Tianshui Huatian Technology Co., LTD.

Title			
LQFP80L (1010X1.4) POD			
DWG No.		REF No.	
HTFL0801010		JEDEC MS-026	
Unit	REV.	Effective Date	
mm	B	2016/06/22

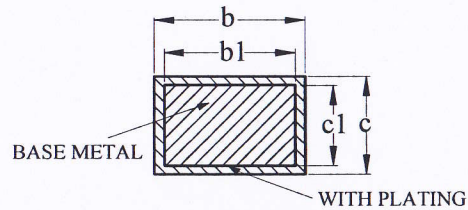
△	changed eB size, from 11.25-11.45 to 11.05-11.25	wangxia	2018.5.28
REV.	Description	Signature	Date
Drafted By	ZHAO Ping	Verified By	QI Zhiqiang
Confirmed By	CHEN Zhixiang	Verified By	HE Naihui
Verified By	HE Wenhai	Approved By	LI Xizhou
